May 3, 2018

Re:	Project Name:	Circle K – Revised Major Final Site Plan
	CH Project No.:	16-0804
	Project Number:	P166-002
	Application Type and Number:	D059 201700358
	Report Number:	2018_0418_C166-002_DRT_Staff_FINAL.docx

Please accept this response letter addressing comments provided by staff on April 18th, 2018.

TRELLIS DETAIL

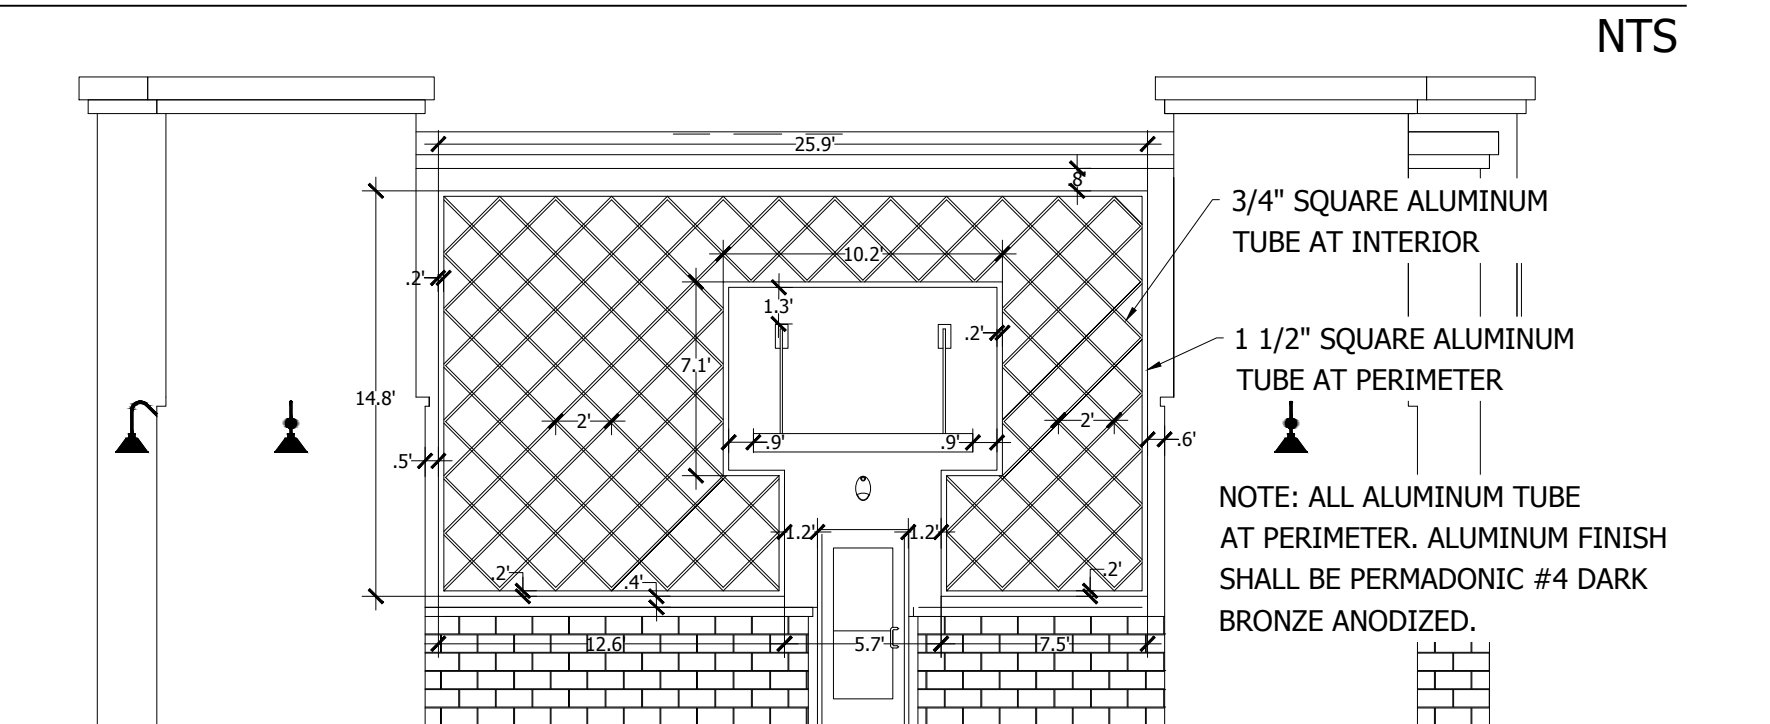
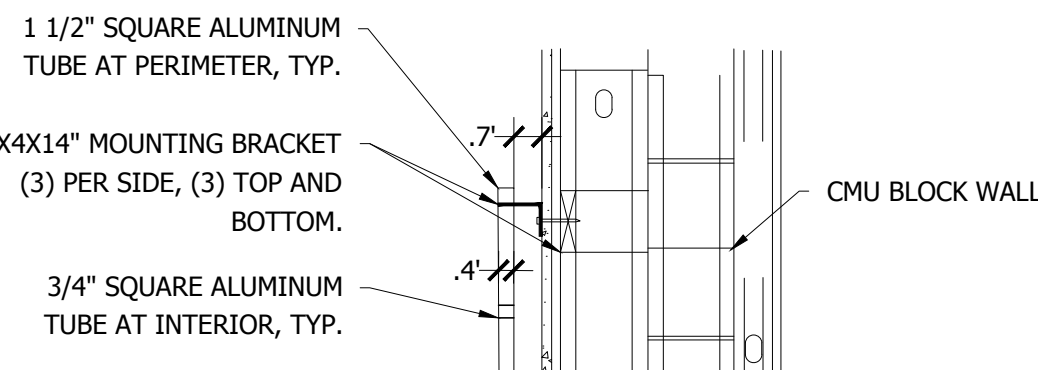
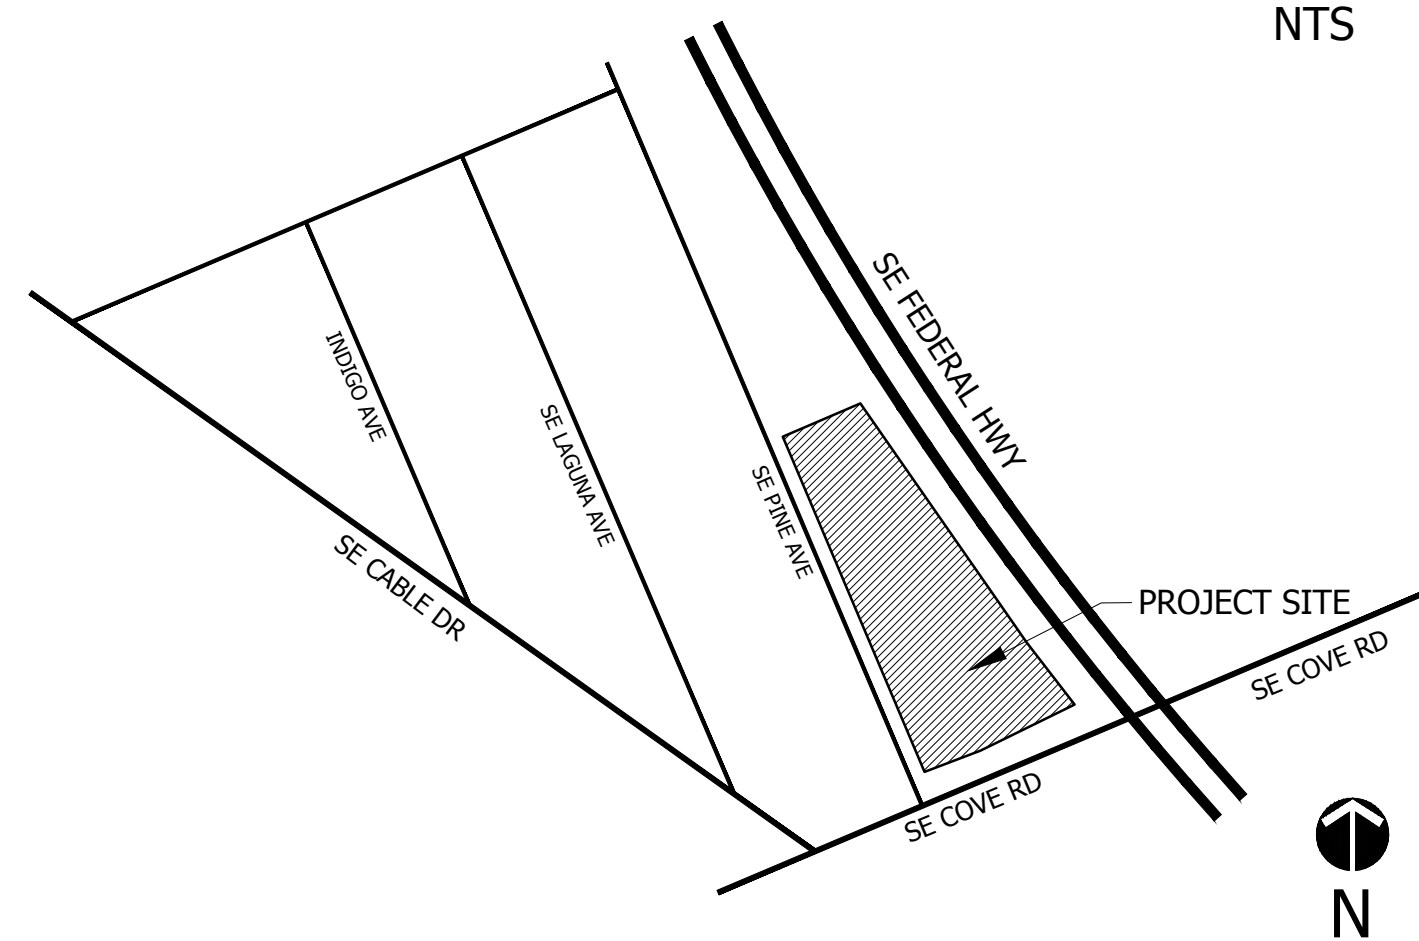
In addition to all other requirements of this subsection 4.872.C, Land Development Regulations, Martin County, Fla. (2013), developments located at an intersection of two or more arterial or collector streets shall provide a prominent architectural feature such as, but not limited to a monument, sculpture or clock tower to emphasize their location as gateways and transition within the community. SECTION 4.872.C.5., LDR, MARTIN COUNTY, FLA. (2013)

Please show on the Site Plan the required architectural feature.

[Applicant Response: Acknowledged, an architectural element has been added to the site plan emphasizing the location as a gateway. It has been added to the corner of SE Federal HWY and SE Cove Rd.](#)

TREE PROTECTION DETAIL

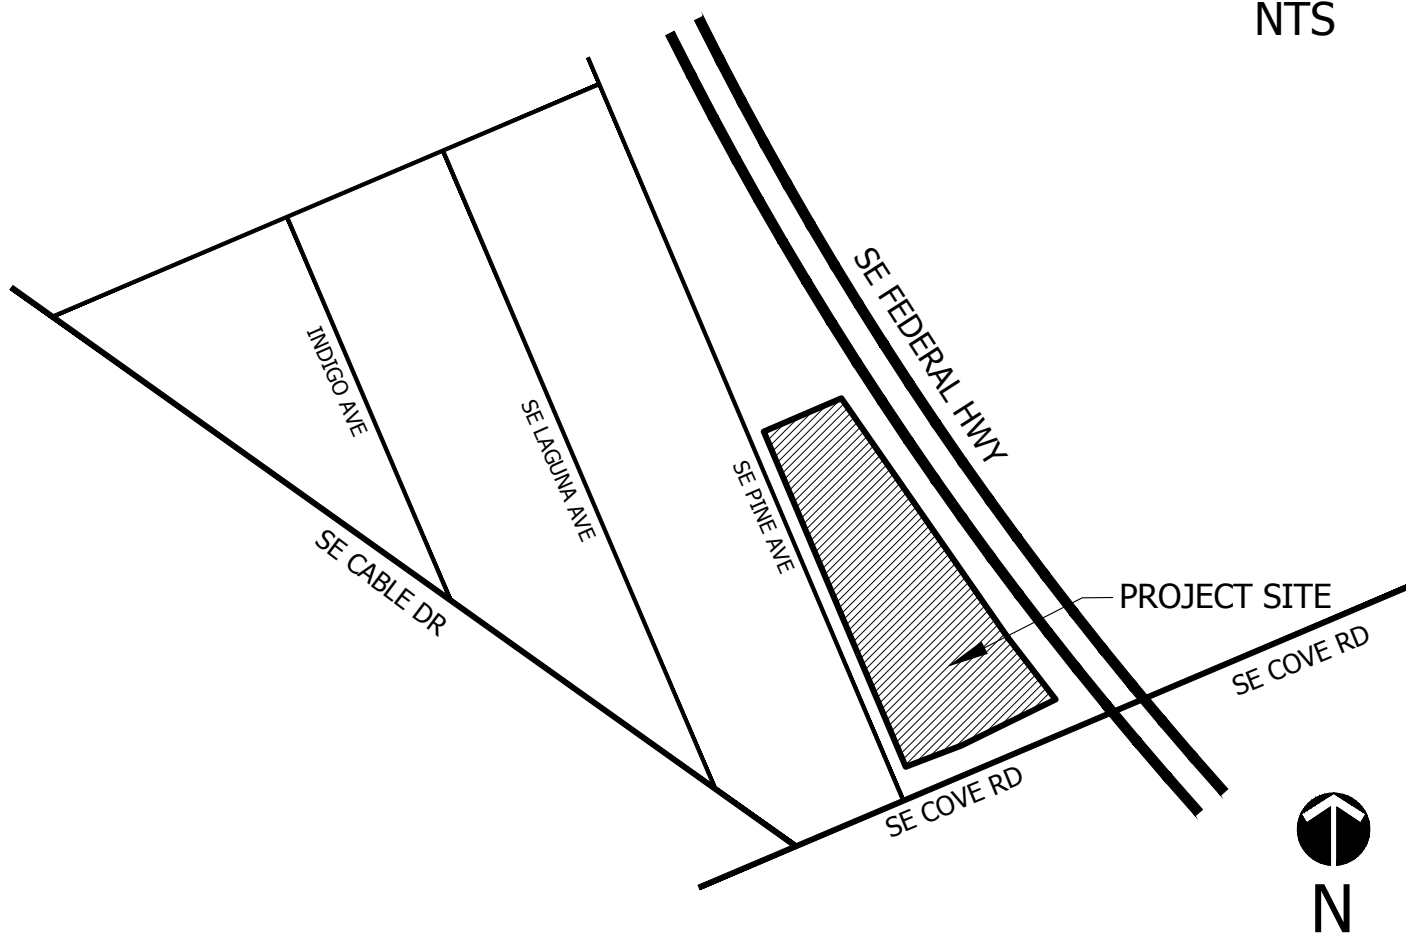
Tree protection must be shown on both landscape plans and construction plans. Provide detail of tree barricade on construction plans. Note to refer to landscape plans is not sufficient direction to site contractor.

4.9.18. Tree barricade locations are not shown on construction plans, provide detail of tree barricade on clearing plans. Response letter states that tree barricade detail is shown on site plan and construction plans; however, I cannot find this detail. Detail does not need to be on the site plan.

[Applicant Response: Acknowledged. The tree protection detail has been added to the construction plans on sheet ES2.0](#)
